## DEPARTMENT OF NATURAL RESOURCES

May 22, 2008

Subject: Conditional Approval of Stockpile Removal Amendment to Notice of Intention to Commence Large Mining Operations and Reclamation Surety, Denison Mines, Tony M Mine, M0170049, Tasks 2325 and 2384, Garfield County, Utah

Surface Facilities Map - Portal Area

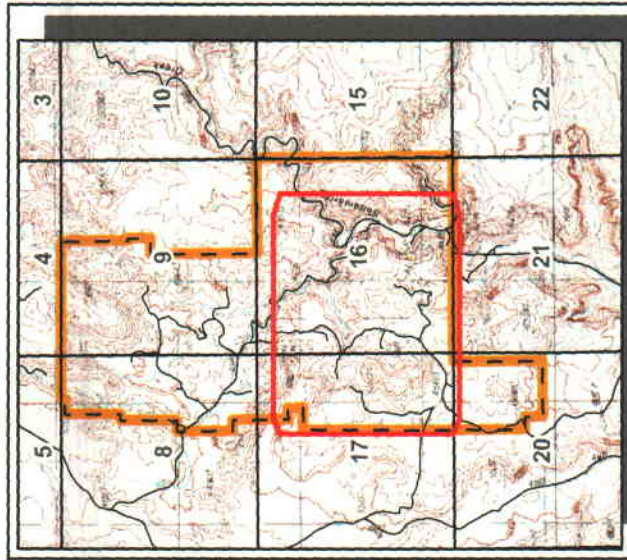
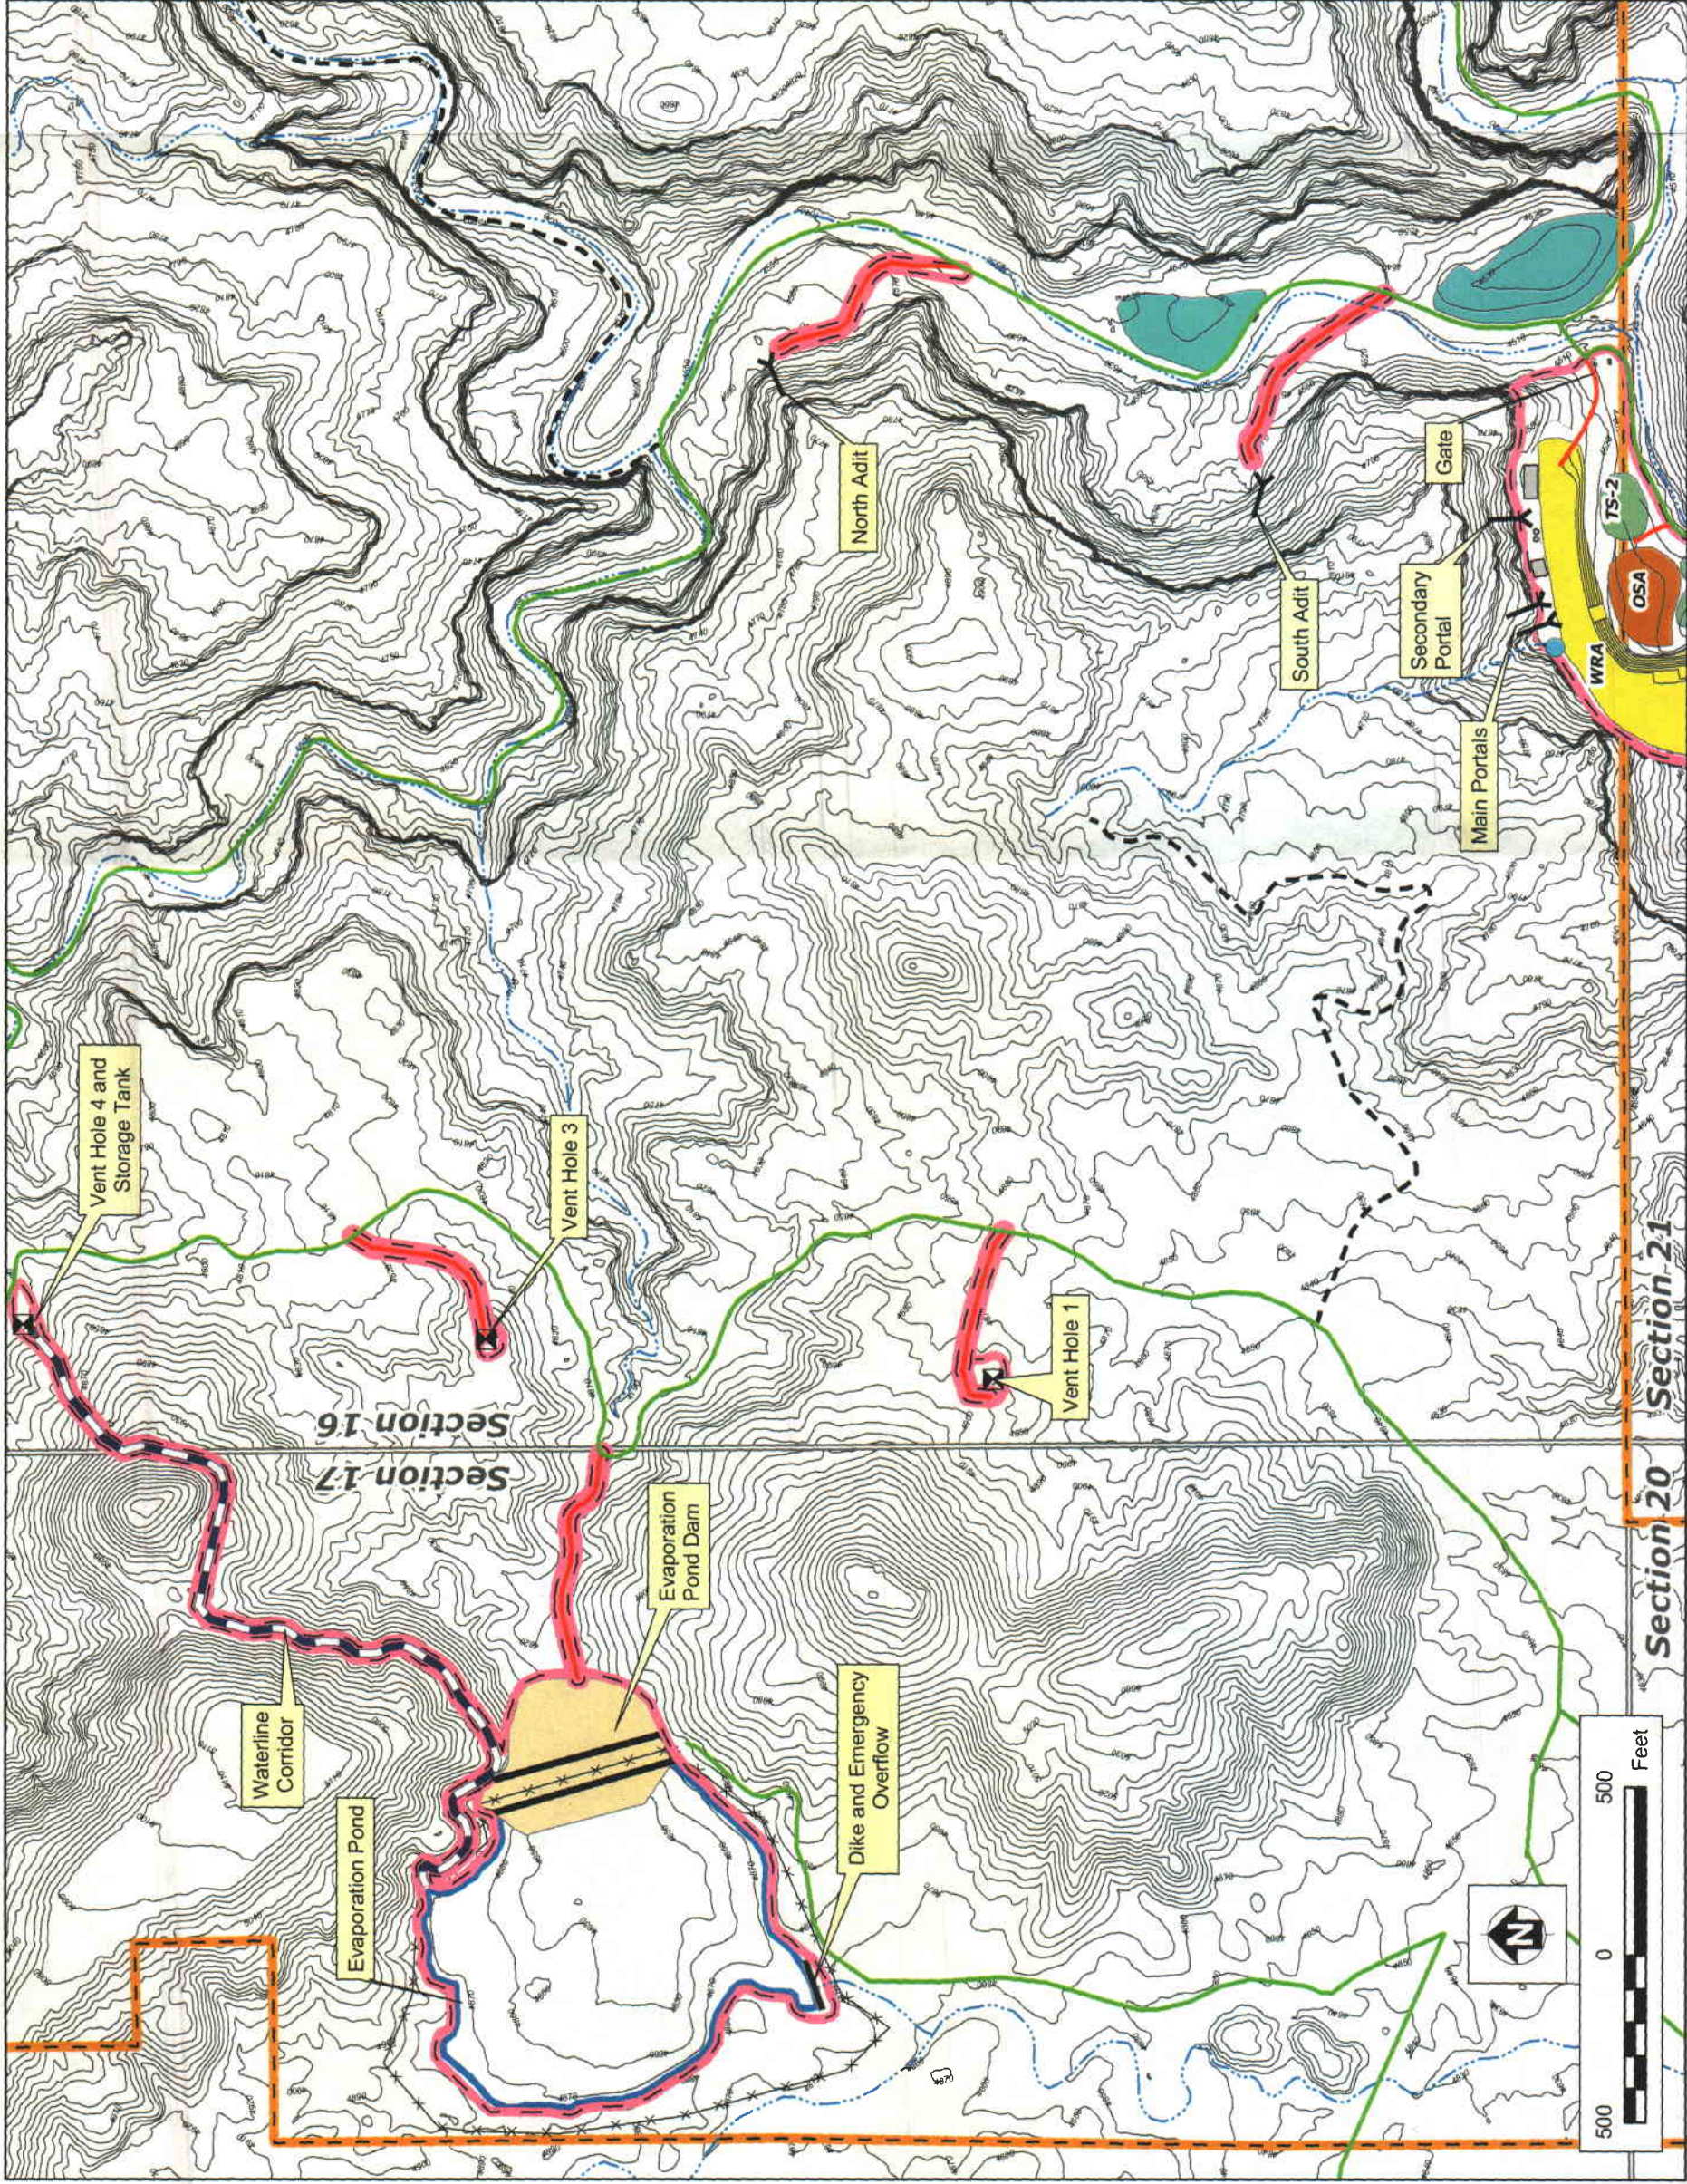
Condition 1: Within 30 days of receipt Figure 4A, 4B, 5, and 7 must be updated to show the Utah State Lease Stockpile is included in the "Surface Disturbance Area".
